Volume IV
RESPONSE TO COMMENTS
ON THE
DRAFT ENVIRONMENTAL IMPACT REPORT
State Clearinghouse No. 2009061113

LYTLE CREEK RANCH
SPECIFIC PLAN

Lead Agency:
City of Rialto
Development Services Department
150 South Palm Avenue
Rialto, California 92376

May 2010

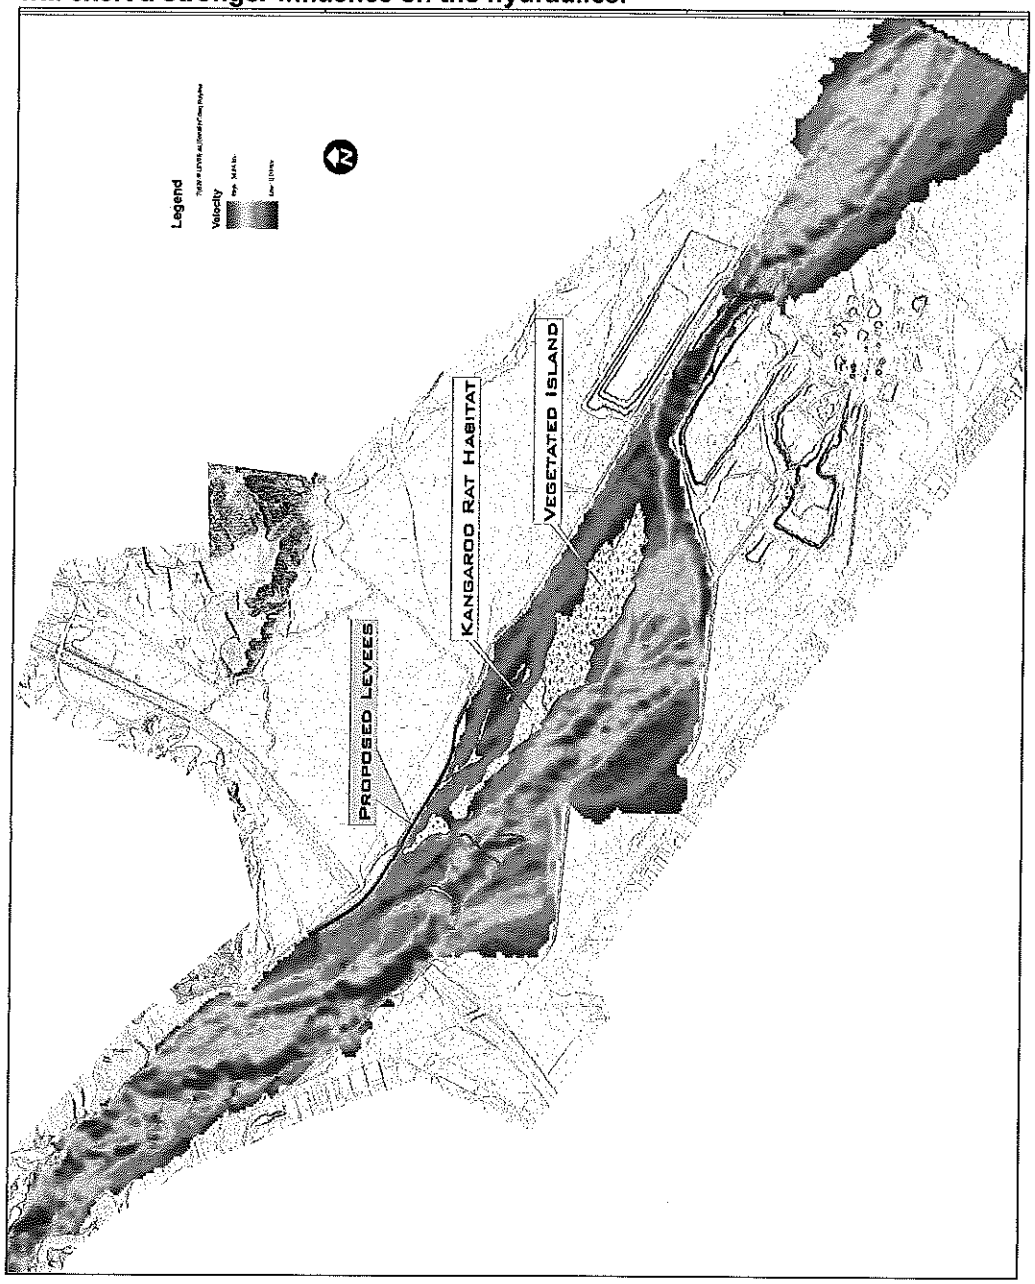
Comment (I-9-7): *The Department recommends including a discussion to identify and mitigate the impacts of the foreseeable future channelizing of the system to protect the proposed levees and infrastructure.*

The construction of the proposed revetment will result in limited reduction of the available hydraulic flow area within the portion of the floodplain where encroachment occurs since these encroachments are primarily along "ineffective" flow areas associated with the shadow effects from the existing groins, compared to the pre-project conditions. The encroachment into the floodplain will result in minor modifications to the average hydraulic characteristics, however, detailed hydraulic modeling of the floodplain conditions has indicated that the potential changes to the floodplain hydraulics from the encroachment are relatively small and are dissipated quickly because of the dynamic nature of the floodplain. Two different floodplain hydraulic models were

used to assess the impacts which included a one dimensional HEC-RAS model and a two dimensional FLO-2D model which provide an enhanced level of accuracy through the use of digital topography. Utilizing the two different models provided the opportunity to evaluate different scenarios and perform different sensitivity analysis in order to validate the models. This also greatly assisted in characterizing changes of the geometry of the active streambed associated with the variable conditions. The updated floodplain was utilized to quantify the potential changes to the floodplain hydraulics from the proposed flood protection revetment systems. The results of this analysis indicated that the potential changes from the revetment systems to key hydraulic characteristics such as depth, velocity, average shear stress, and cross sectional flow area are relatively minor. This would generally be expected from the limited encroachment of the proposed revetment systems within the floodplain since (1) the side effects on hydraulically "wide" channels have limited effect on the average hydraulics, and (2) the hydraulic regime is close to critical depth so the channel geometry downstream of the revetment will exert a stronger influence on the hydraulics.

The FLO-2D analysis illustrates the existing "baseline" floodplain conditions and how the locations of high and low velocity are distributed within the floodplain. The graphic also illustrates that the proposed development is occurring within the "ineffective" flow" zone where the velocities are low because of the groin shadow effect. Also, where the majority of the flow is within an incised active channel with adjacent overbank terraces, such as downstream of the CEMX levees, then there will be locations of shallow flooding on elevated floodplain terraces which will have very low velocities on these terraces since the majority of the flow is within the active channel system. The active channel downstream of the CEMEX levees and extending to the Cajon Creek confluence has become incised over time because of the historical response to the gravel mining in the Cajon confluence area. The lowering of the channel invert has resulted in minimizing the amount of flow from larger storm events which is conveyed on the overbanks or terraces as illustrated on the FLO-2D exhibit which depicts lower velocities with shallow flooding in these areas.

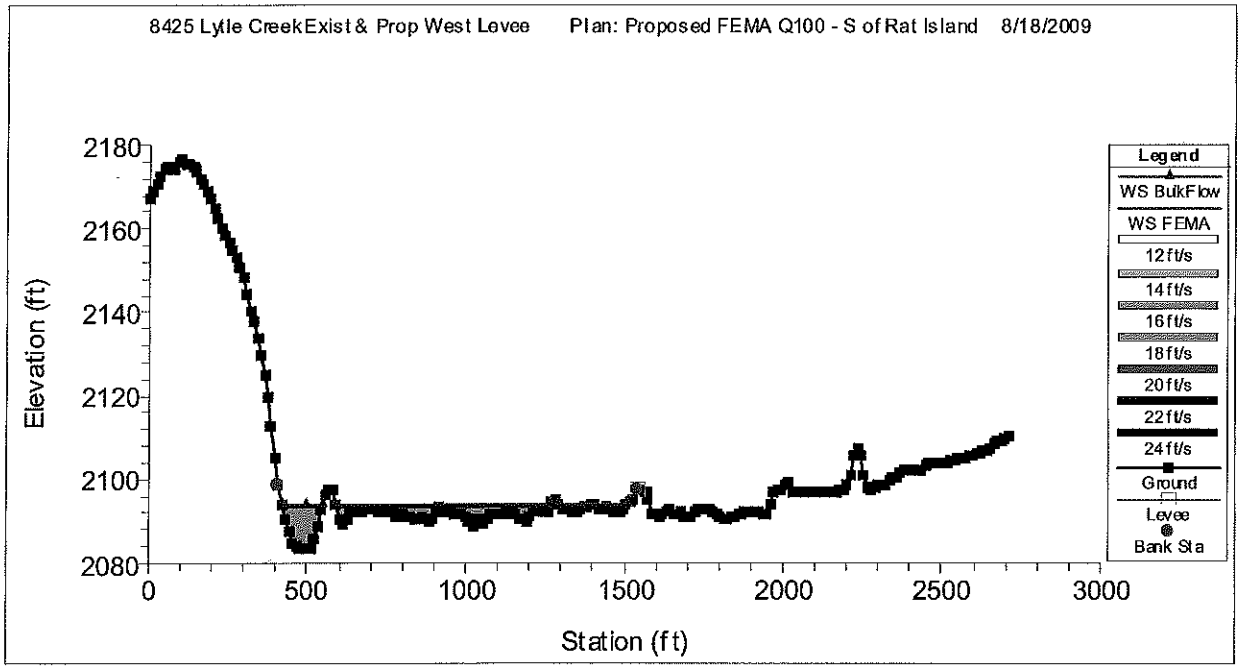
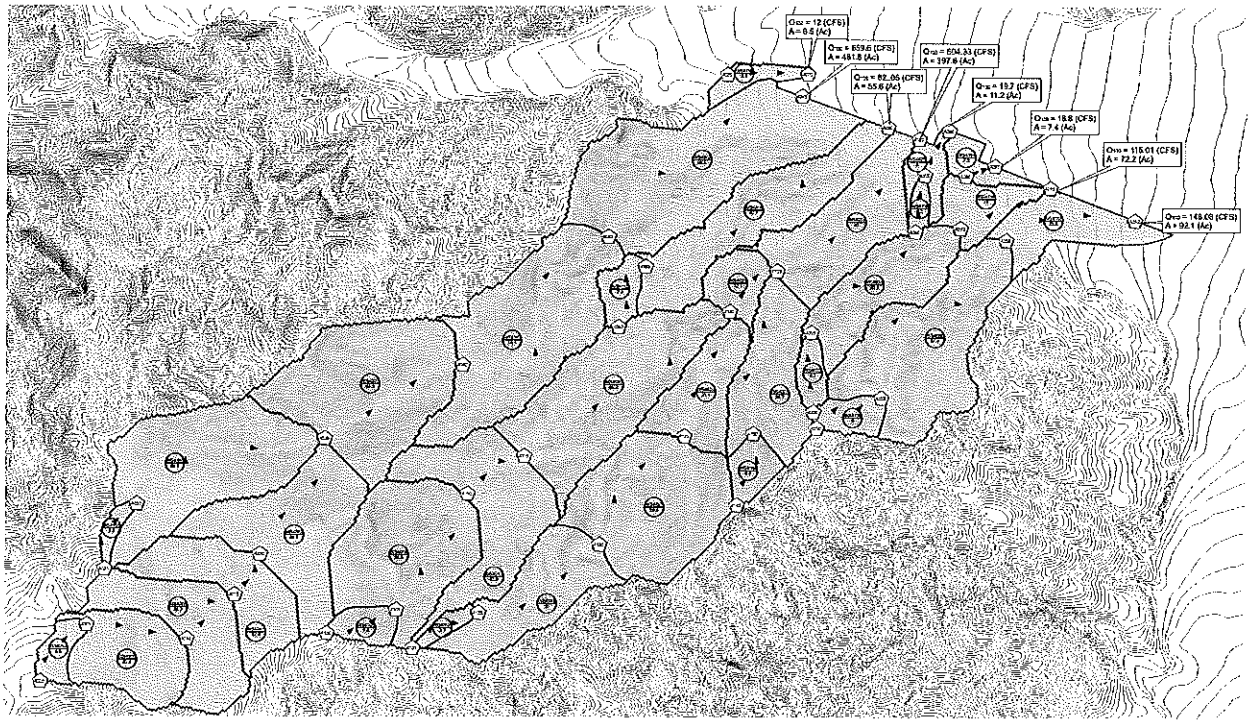
Comment (I-9-30): (24) A discussion of the encroachment of proposed development east of S. Lytle Creek Road within the floodplain and a history of flooding and protection of S. Lytle Creek Road.

Response: **There are two separate issues which are discussed in this comment that will be addressed with this response. These issues include (1) encroachment of development east of South Lytle Creek Road within the existing Lytle Creek floodplain, and (2) flood protection associated with historical flooding along South Lytle Creek Road. Regarding the first issue, the proposed development was specifically oriented to minimize/avoid encroachment into the existing "active" floodplain through alignment of the revetment so that it followed the active streambank. The proposed revetment will follow along the horizontal alignment of the existing western bank which defines the limit between the active channel and older overflow terraces from the historic fan. The western bank appears to have been previously established with the original construction of the I-15 freeway to assist in directing flow to the bridge. The bank alignment is illustrated in the following representative cross section of the floodplain which depicts the location of the active channel bank on the right side of the cross section which the 100-year water surface elevation is below the level of that existing embankment. Although the cross section does not illustrate the proposed fill to the right of the existing streambank, this area will be elevated through earthen fill to an elevation that is above the existing top of streambank. The area to the right of the existing embankment is no longer within the active 100-year floodplain as illustrated in the cross section geometry of the existing stream. This ensures that the proposed revetment will not influence the floodplain hydraulics from removal of effective flow area since it follows an alignment consistent with the active floodplain boundary along the fringe of the floodplain. Hardening of the streambank should not change the hydraulic characteristics of the floodplain since the armoring of the streambank with the revetment will be identical to the existing composition of the existing bank that is heavily armored with very large cobbles.**

The <u>second issue</u> is related to the proposed project flood protection addressing the historical flooding along South Lytle Creek Road. The existing historical flooding that occurs along South Lytle Creek Road is associated with the local watershed tributary to the west of the road which delivers a significant quantity of runoff and the existing drainage facilities along the road, which consist of small earthen ditches / culverts which have very limited hydraulic capacity. The existing watershed areas tributary to the east and offsite of the project were studied in detail as part of the baseline hydrology analysis for the project drainage masterplanning efforts. The results of these studies and the technical data are included in the "Preliminary Master Plan of Drainage & Stormwater Management - Lytle Creek Ranch Project" (PACE, 2007). The three largest tributary streams from the west deliver 461, 397, and 55 acres of offsite natural drainage area which consist almost entirely of natural watershed areas. The estimated 100-year flowrate generated by these watersheds can exceed well over 1,000 cfs and result in localized flooding along South Lytle Creek Road since the existing drainage facilities with ditches and small culverts are designed to convey nuisance flowrates. However, the ultimate drainage patterns for these flows that originate to the west are directed to the east based on the topography and surface drainage patterns, across the proposed development. The following exhibit illustrates the hydrology map for the baseline offsite watershed analysis and the tributary drainage area delineations which provides an understanding of the magnitude of the offsite watershed. The results of the "offsite" baseline hydrology analysis were utilized in order to masterplan future drainage facilities that could intercept the offsite flowrates from the western watershed and deliver them to Lytle Creek where they would naturally discharge. The proposed drainage facilities designed to intercept these flowrates would alleviate the majority of the existing flooding condition associated with the offsite watersheds.
